**PLANNING COMMISSION**  
**WEDNESDAY, FEBRUARY 14, 2024**

**PLANNING COMMISSION  
RESOLUTION NO. LP24-0001**

**A RESOLUTION OF THE CITY OF WILSONVILLE PLANNING COMMISSION  
RECOMMENDING THE WILSONVILLE CITY COUNCIL AMEND THE TEXT OF THE DEVELOPMENT  
CODE TO MAKE MINOR MODIFICATIONS TO THE COFFEE CREEK INDUSTRIAL DESIGN OVERLAY  
DISTRICT STANDARDS.**

<b>Meeting Date:</b> February 14, 2024		<b>Subject:</b> Coffee Creek Code Amendments	
		<b>Staff Members:</b> Cindy Luxhoj AICP, Associate Planner	
		<b>Department:</b> Community Development	
<b>Action Required</b>		<b>Advisory Board/Commission Recommendation</b>	
<input type="checkbox"/> Motion <input type="checkbox"/> Public Hearing Date: <input type="checkbox"/> Ordinance 1 <sup>st</sup> Reading Date: <input type="checkbox"/> Ordinance 2 <sup>nd</sup> Reading Date: <input checked="" type="checkbox"/> Resolution <input type="checkbox"/> Information or Direction <input type="checkbox"/> Information Only <input type="checkbox"/> Council Direction <input type="checkbox"/> Consent Agenda		<input type="checkbox"/> Approval <input type="checkbox"/> Denial <input type="checkbox"/> None Forwarded <input checked="" type="checkbox"/> Not

# Table CC-3: Site Design Parcel Pedestrian Access

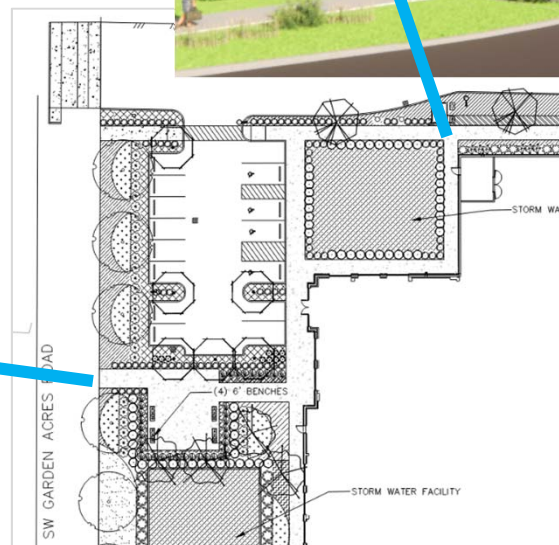
- Limit where 8-foot access width is required

# Table CC-3: Site Design Parking Location and Extent

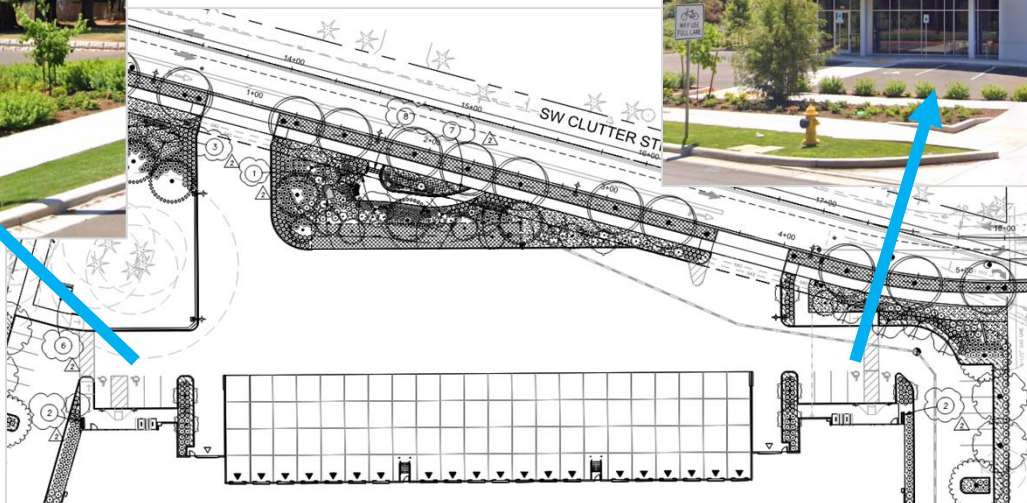
- Eliminate parking bay limit and allow some parking use for longer duration

# Table CC-3: Site Design Grading and Retaining Walls

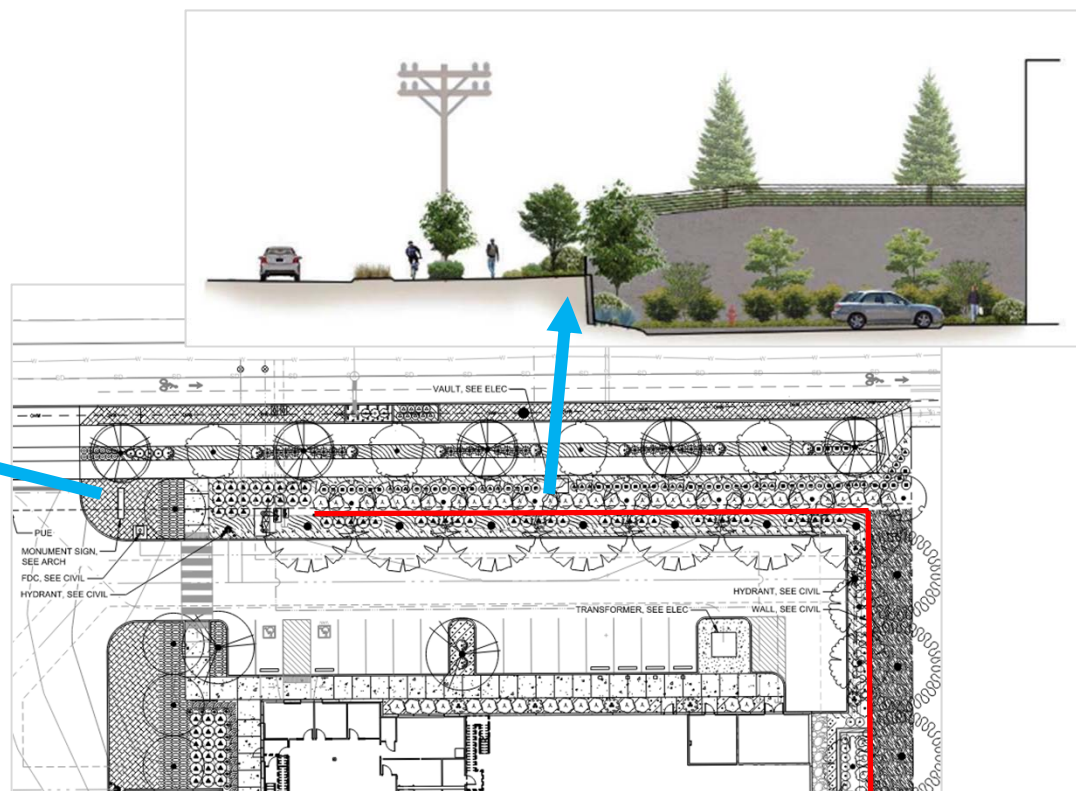
- Increase height of walls not visible from adjacent streets

# Table CC-3: Site Design Grading and Retaining Walls

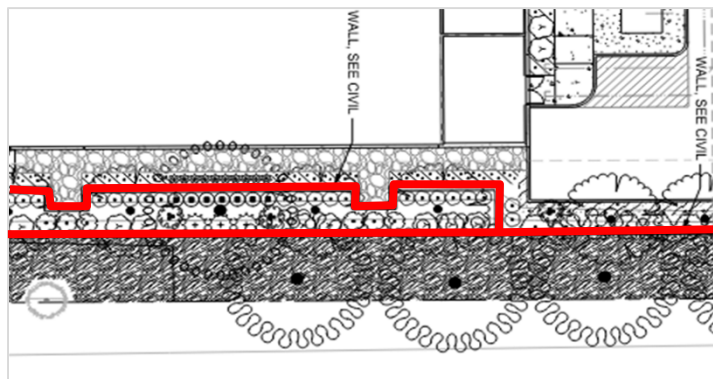
- Clarify meaning of “horizontal offset”

# Possible Modification Example

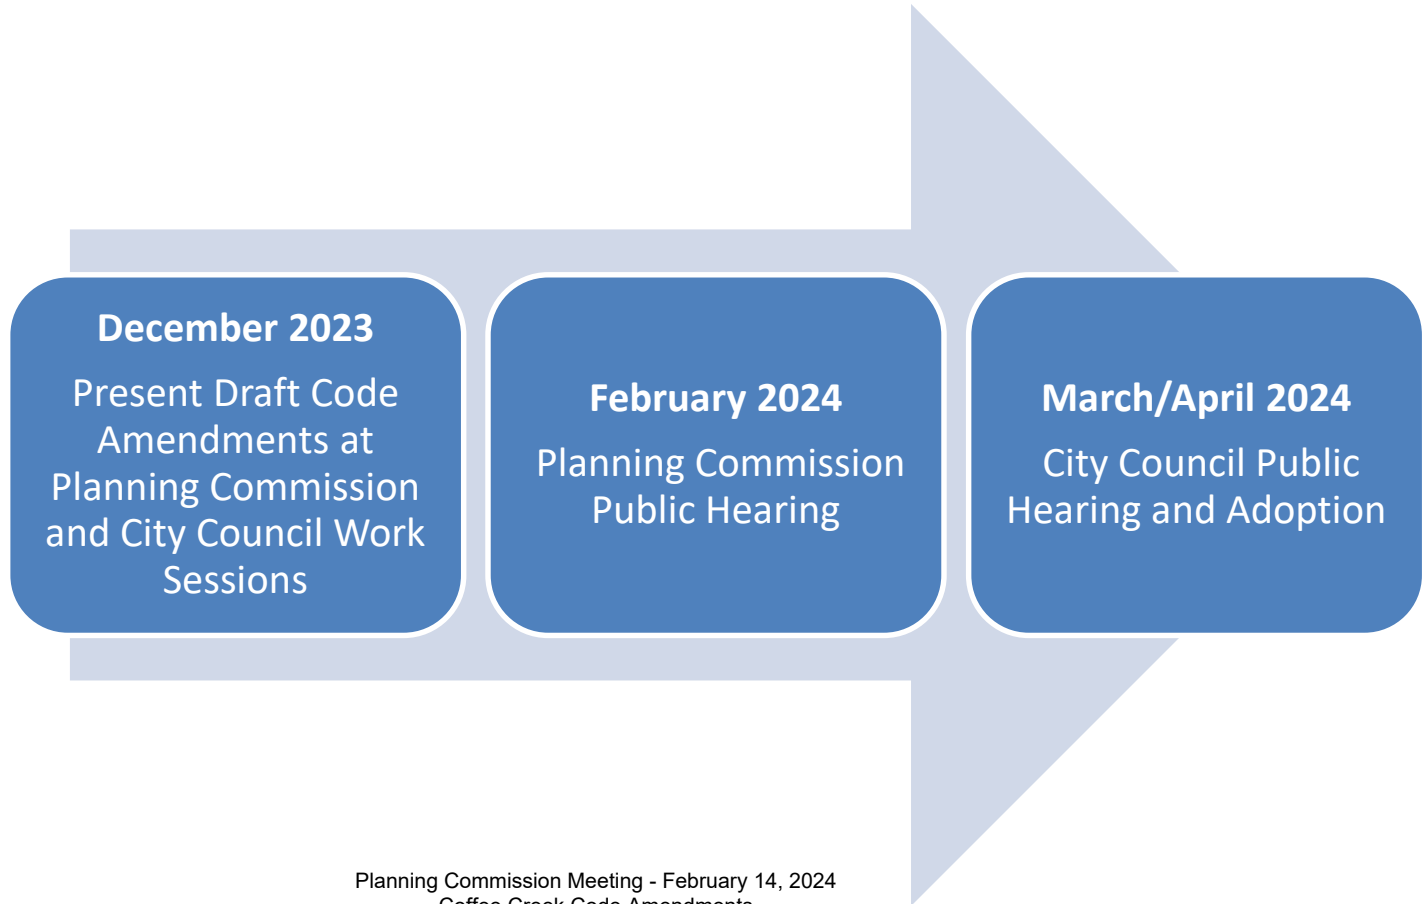
- Required Canopy Height at Primary Building Entrance
  - Current standard:
    - Vertical clearance of 15 feet, minimum
    - All-weather protection zone 8 feet deep, minimum and 15 feet wide, minimum
    - Allowed adjustment: 10% (to 13.5 feet)
  - Possible modifications:
    - Reduce canopy height
      - 12 feet, minimum, consistent with standard storefront dimension, suggested in focused discussions
